Access Compliance Report

Public Rights-of-Way

Intersection ID: 10019095	Main Street: FIREFLY_LN	Cross Street: N/A	Location: SW
ADA ID: E6DF7F5C99CF	Ramp Type: Perp	Initial Pass/Fail: Fail	Overall Compliance: No
Severity Score: 8.75			
Codes/Mitigation Info/Possible Solution		Field Measurements/Component Compliance

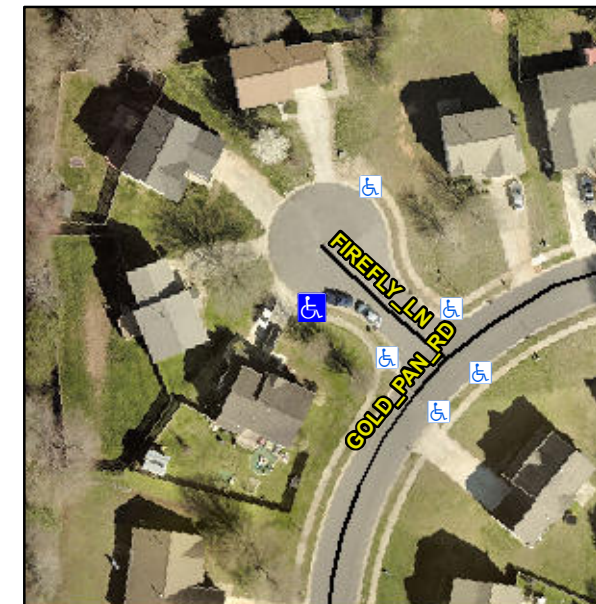
Not Found, R304.5.1

Compliance	Description	Data	Compliance	Description	Data
N/A	Ramp Length (in)	48.0	Yes	Ramp Slope (%)	8.2
No	Ramp Width (in)	47.5	Yes	Ramp XSlope (%)	0.3
N/A	Flare Type LT	N/A	N/A	Flare Type RT	N/A
N/A	Flare Slope LT (%)	N/A	N/A	Flare Slope RT (%)	N/A
N/A	Flare Traversable LT?	N/A	N/A	Flare Traversable RT?	N/A
N/A	Landing Length (in)	N/A	N/A	DWS Provided?	N/A
N/A	Landing Width (in)	N/A	N/A	DWS Contrast?	N/A
N/A	Landing Slope (%)	N/A	N/A	DWS Length (in)	N/A
N/A	Landing X Slope (%)	N/A	N/A	DWS Full Width?	N/A
N/A	Landing Curb? (Y/N)	N/A	N/A	DWS Offset (in)	N/A
N/A	Shared Landing?	N/A			
N/A	Gutter Ponding?	N/A	N/A	Gutter Slope (%)	N/A
N/A	Gutter Lip Ht (in)	N/A	N/A	Gutter X Slope (%)	N/A
N/A	Painted X Walk1?	No	N/A	Painted X Walk2?	N/A
	X Walk 1 Direction	To NE		X Walk 2 Direction	N/A
N/A	X Walk 1 Width (in)	N/A	N/A	X Walk 2 Width (in)	N/A
	X Walk 1 Slope (%)	5.0		X Walk 2 Slope (%)	N/A
	X Walk 1 X Slope (%)	0.9		X Walk 2 X Slope (%)	N/A

Remove & Replace Entire Ramp.
